ARCHITECTURAL REVIEW COMMITTEE MEMORANDUM

DATE: MARCH 7, 2022 UNFINISHED BUSINESS

SUBJECT: ONE LAS PALMAS, LLC FOR A MAJOR ARCHITECTURAL APPLICATION FOR THE REVIEW OF FOUR (4) SINGLE-FAMILY HOUSE TYPES ON ELEVEN (11) HILLSIDE LOTS AND AN ADMINISTRATIVE MINOR MODIFICATION FOR A FRONT YARD SETBACK REDUCTION FOR THREE LOTS AND INCREASE IN BUILDING HEIGHT FOR FOUR (4) HOUSE ELEVATIONS LOCATED AT LAS PALMAS ESTATES DRIVE, ZONE R-1-B, SECTION 1. (CASE 3.4194 MAJ & 7.1648 AMM)(GM)

Topographical Survey

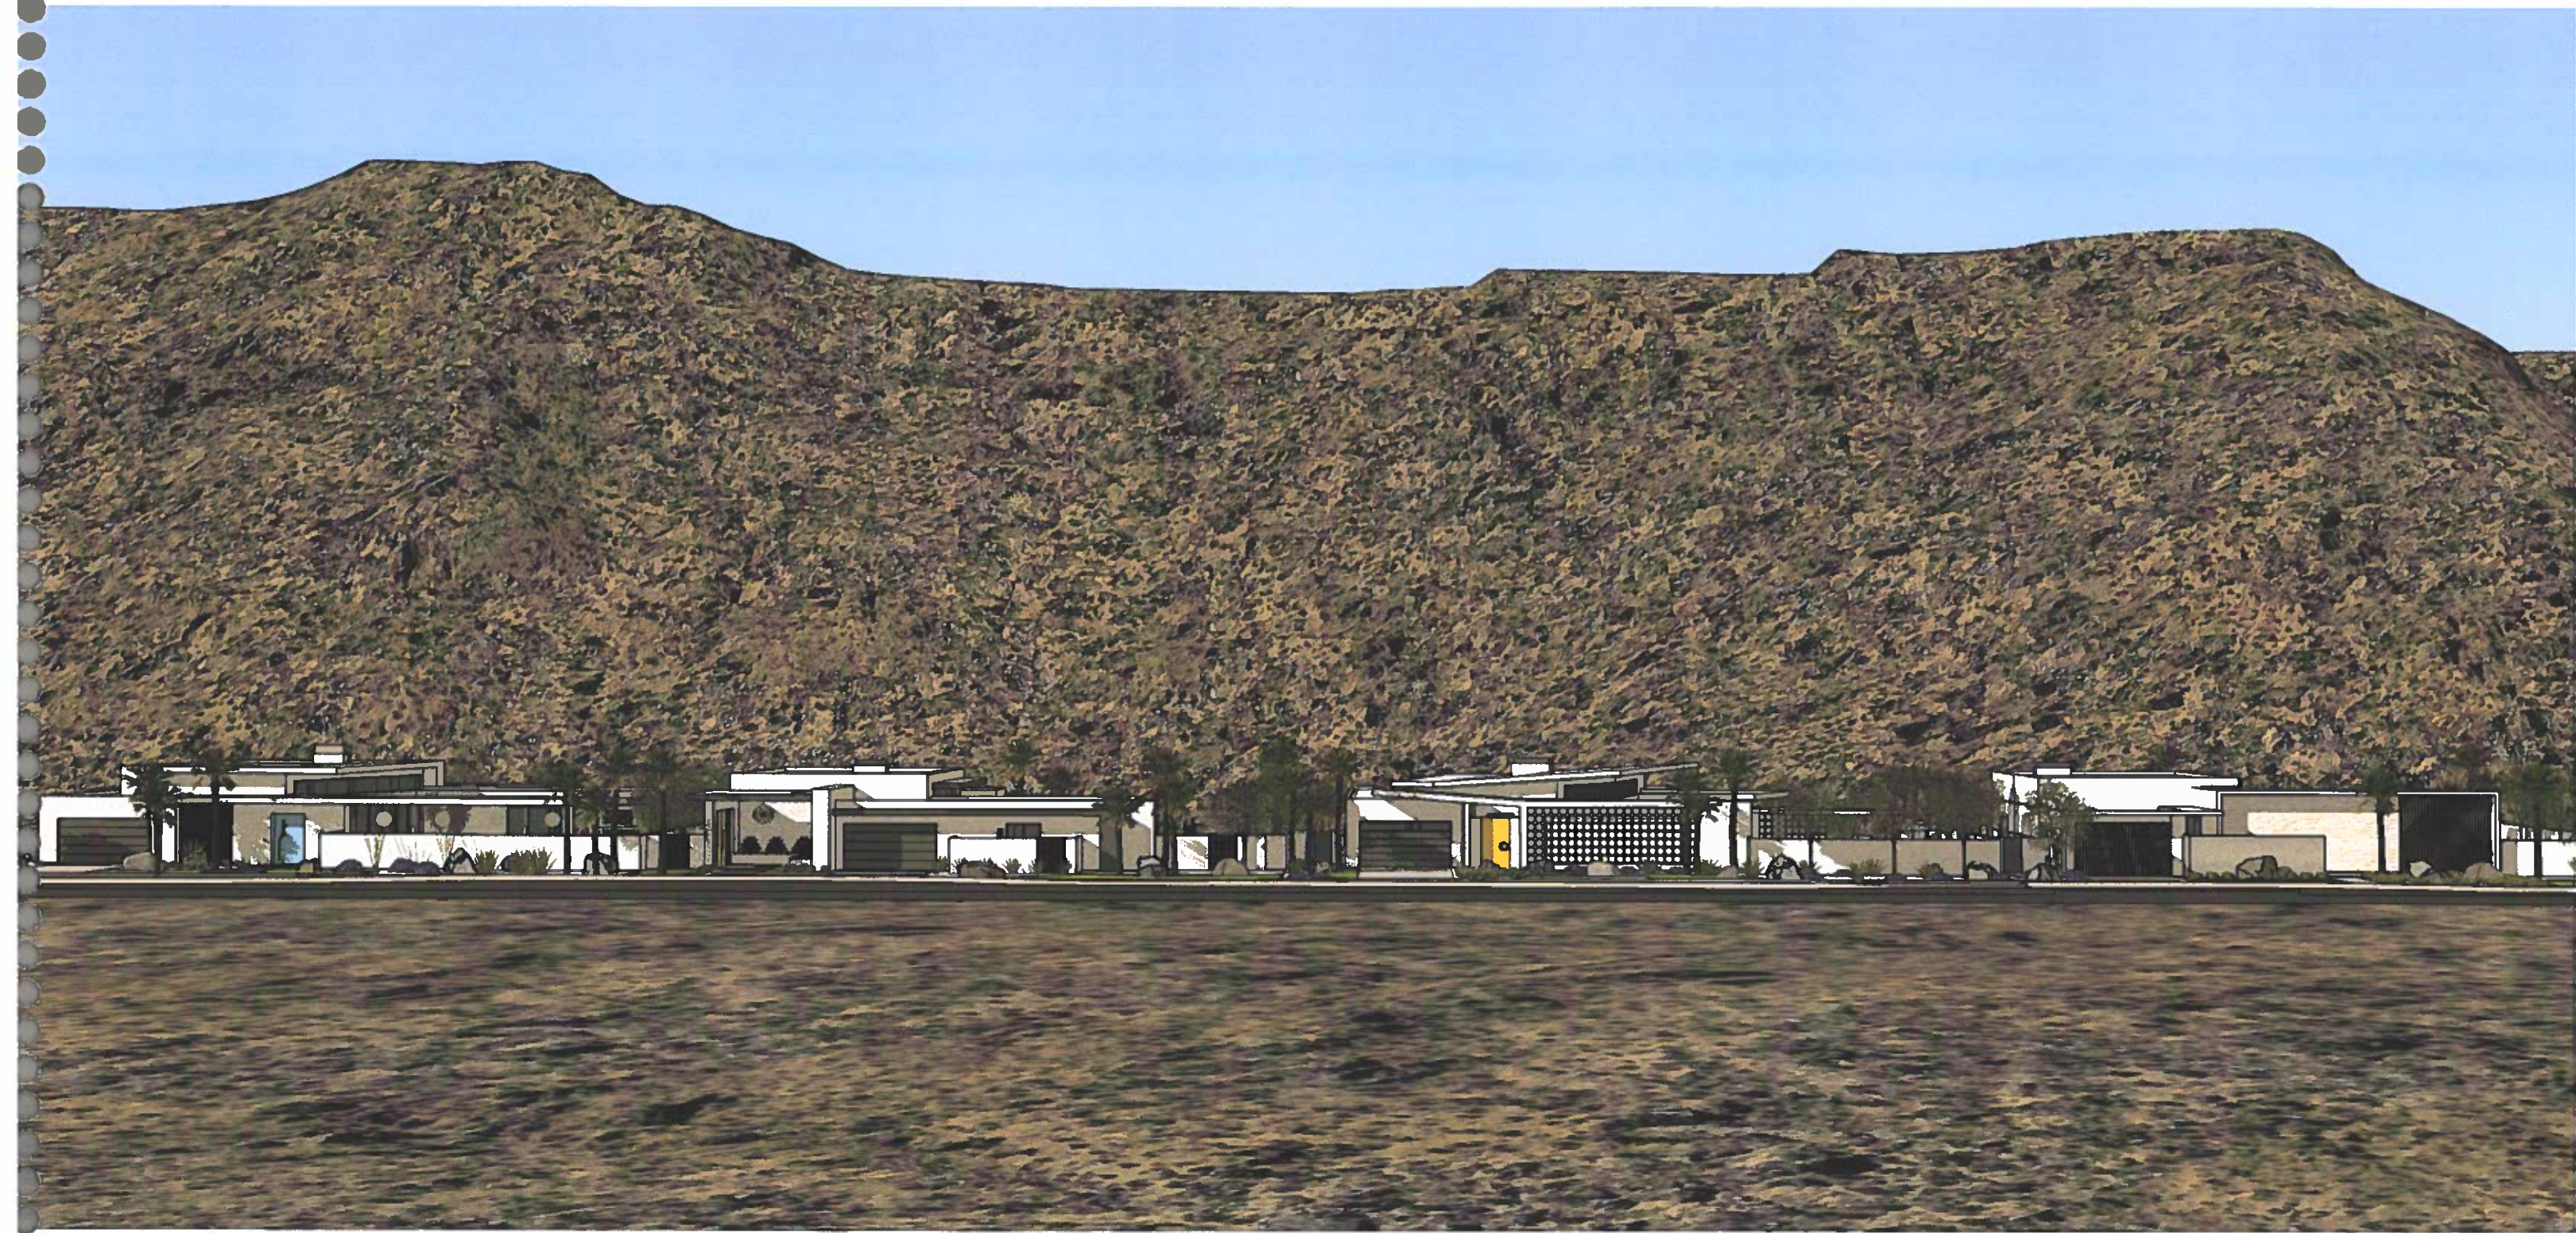
3. Pad Heights and Drainage Plan.

The applicant has shown each lot pad height on the topography survey. The subdivision slopes from west to east with the higher end at the dam spillway at 541 feet to the main entrance having a pad elevation of 520 feet. In addition, a typical drainage plan has been developed that shows the water flows from the mountain around each house and onto the street.
